CONTRACT CHANGE ORDER

CCO: 64 **Suppl. No. 0** **Contract No. 04 – 0120F4** **Road** SF-80-13.2/13.9 **FED. AID LOC.:**

Modify tower strut façade, clarify holes in cross-bracing flanges and boss plates, and correct fillet weld details as shown on sheets two (2) through five (5) of this change order. The following revised contract plan sheets detail all changes: 0573R1, 574R1, 575R2 and 920R1 (of 1204).

SAN FRANCISCO OAKLAND BAY BRIDGE
EAST SPAN SEISMIC SAFETY PROJECT
SELF-ANCHORED SUSPENSION BRIDGE
(SUPERSTRUCTURE & TOWER)

TOWER STRUT FACADE DETAILS NO.2

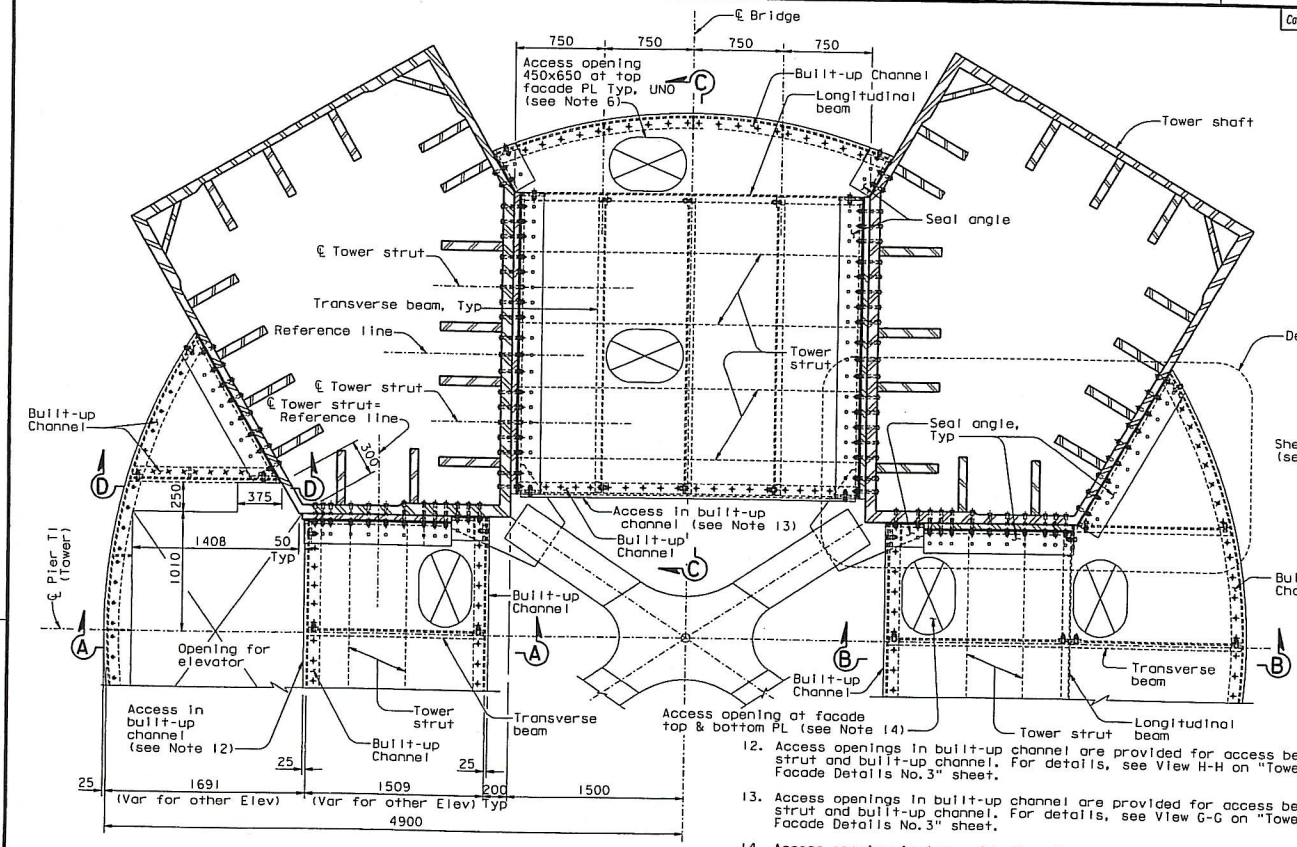
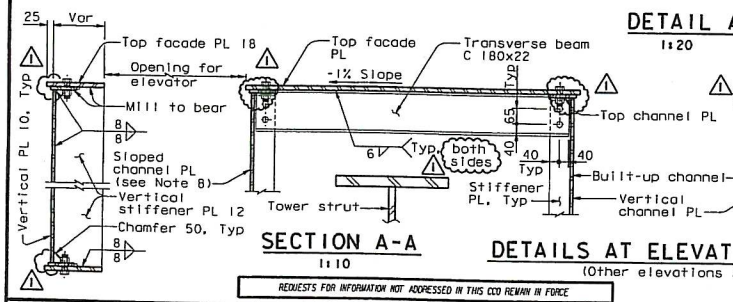
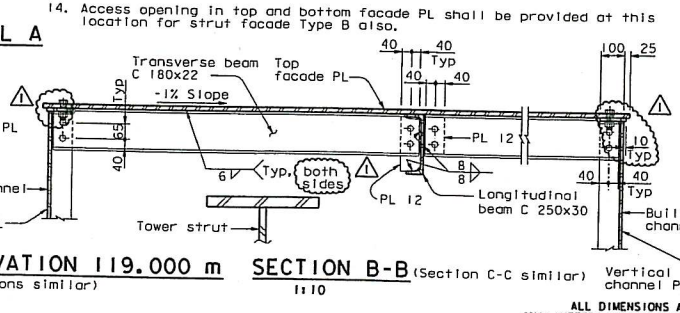
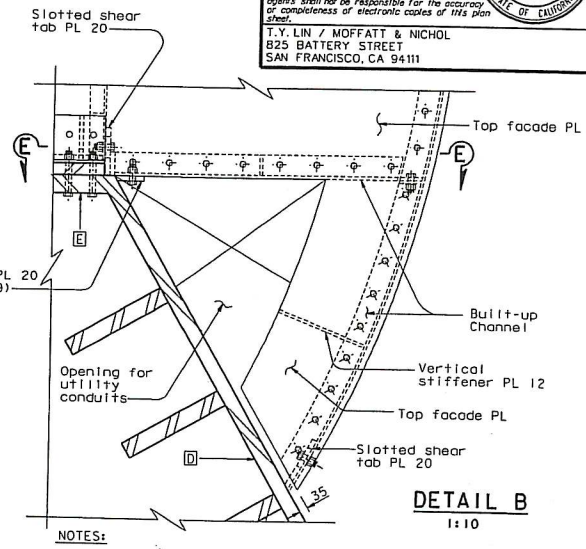
MARK	DATE	DESCRIPTIONS	BY	CH'D	CCO#
1	07/11/08	TOWER STRUT FACADES AND CROSS BRACING	NPJ	NV	64

TOWER STRUT FACADE DETAILS NO. 3

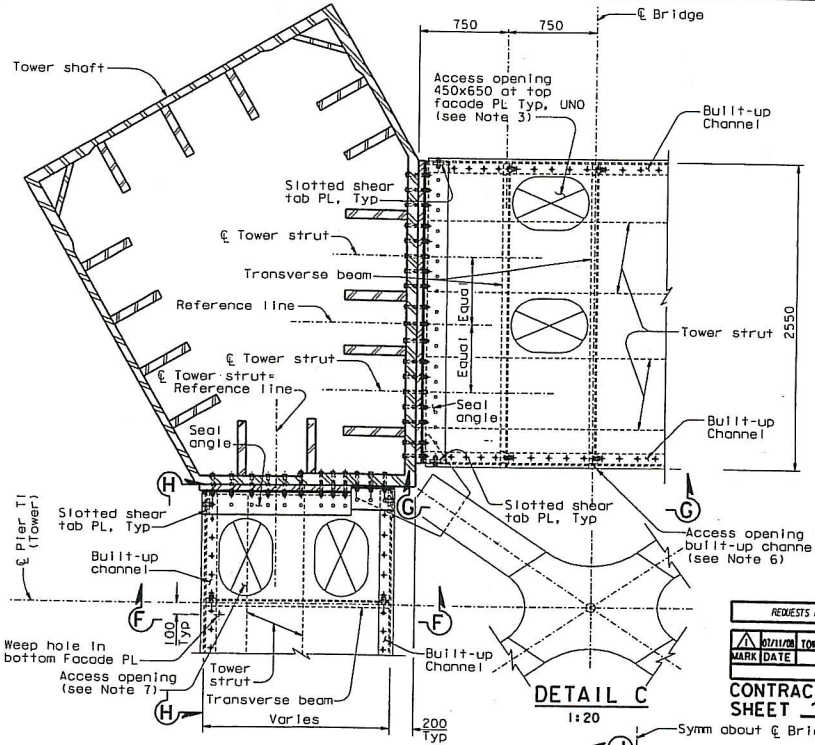
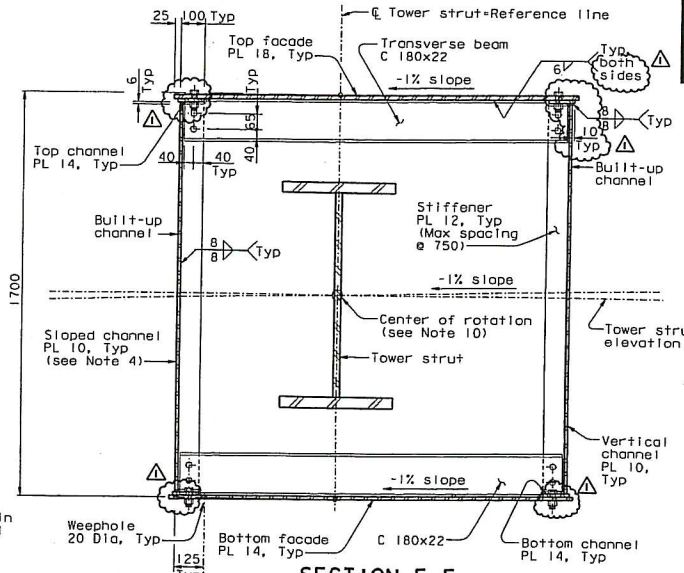
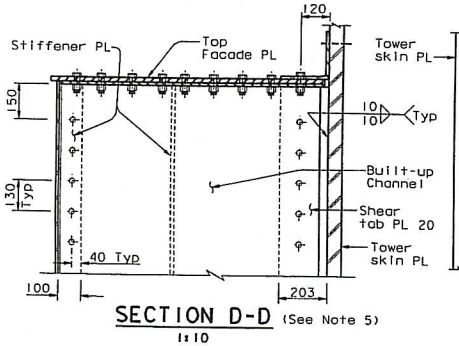
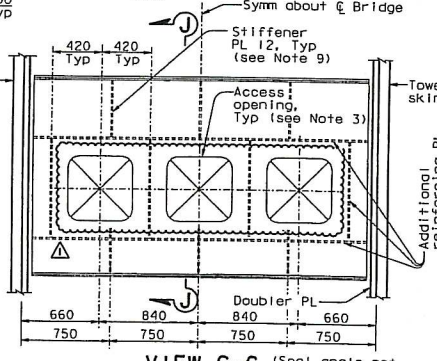
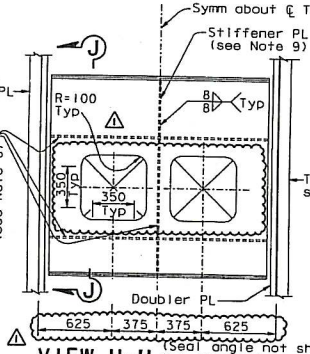
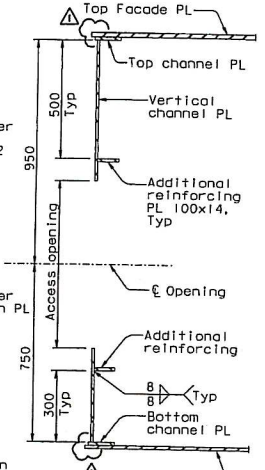
REQUESTS FOR INFORMATION NOT ADDRESSED IN THIS CCO REMAIN IN FORCE				
MARK	DATE	REVISIONS DESCRIPTIONS	BY	CH'D	CCO#
1	07/11/08	TOWER STRUT FACADES AND CROSS BRACING	MN	NV	64

TOWER STRUT FACADE DETAILS NO. 4

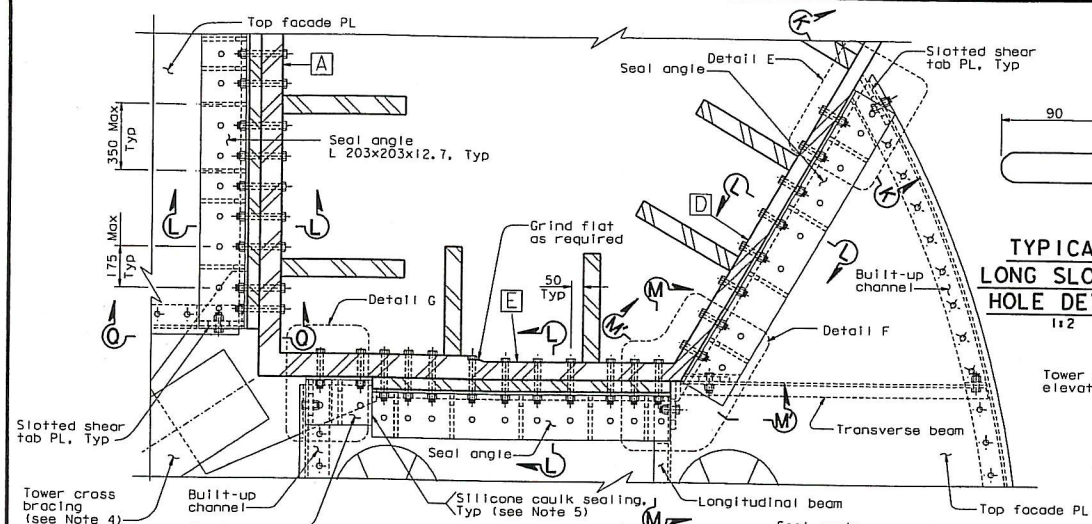
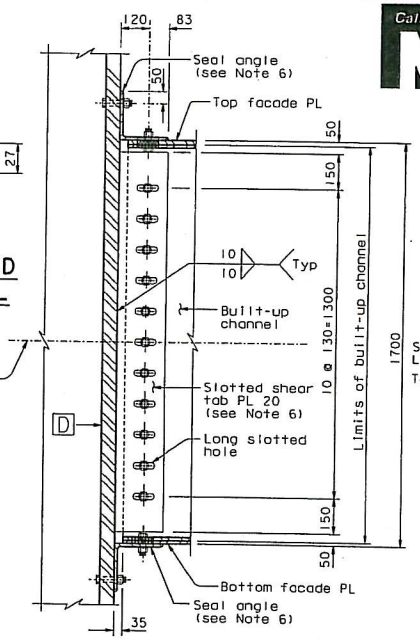
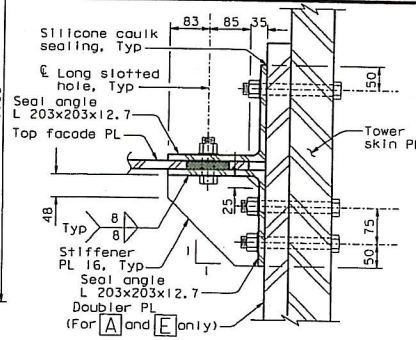
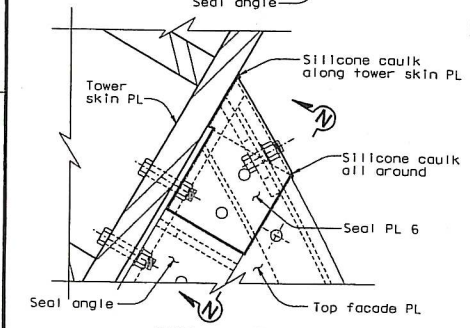
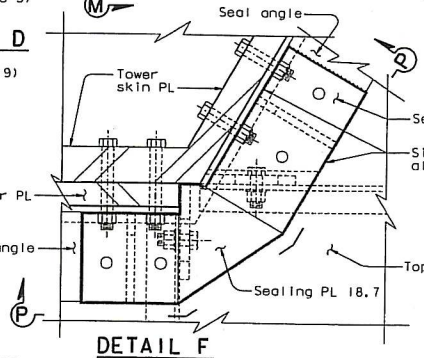
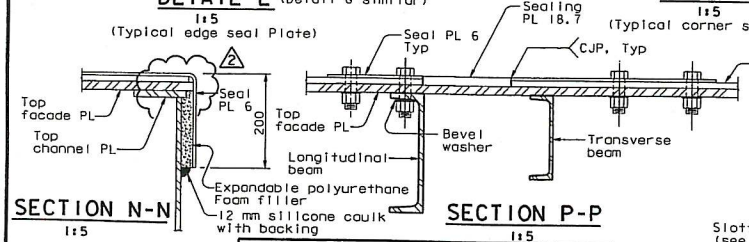
MARK	DATE	DESCRIPTIONS	BY	CH'D	CCO#
		REVISIONS			
2	07/11/08	TOWER STRUT FACADES AND CROSS BRACING	NV	MN	64
1	08/01/01	TOWER STRUT FACADE PTFE	NV	MN	48

TOWER ACCESS DETAILS NO. 4

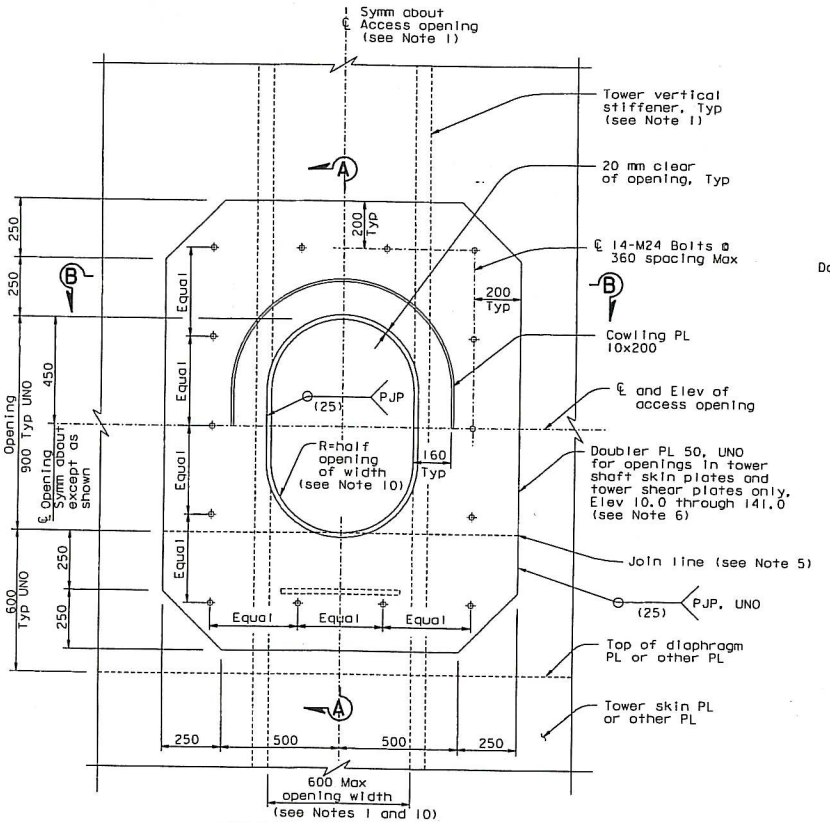
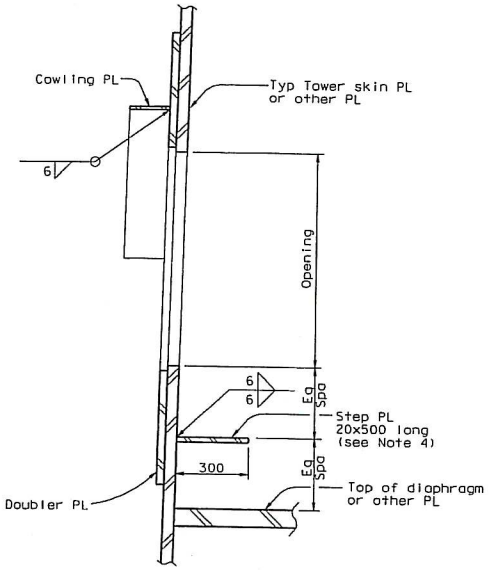
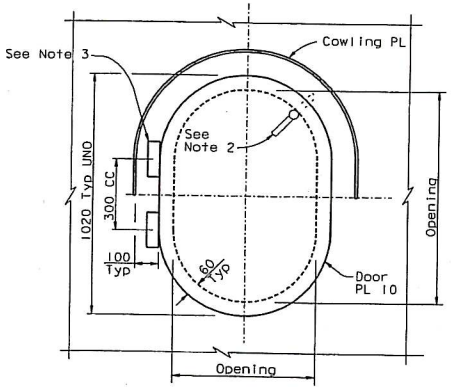
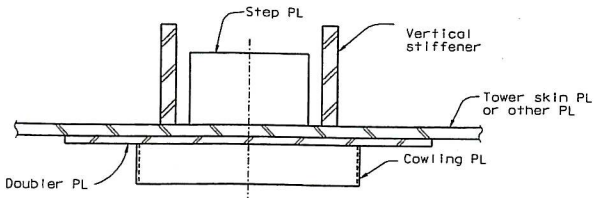
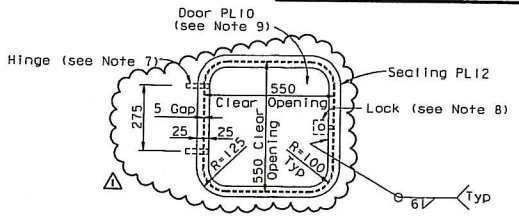
MARK	DATE	REVISIONS	BY	CH'D	CCO#
1	07/11/08	TOWER STRUT FACADES AND CROSS BRACING	MN	NV	64
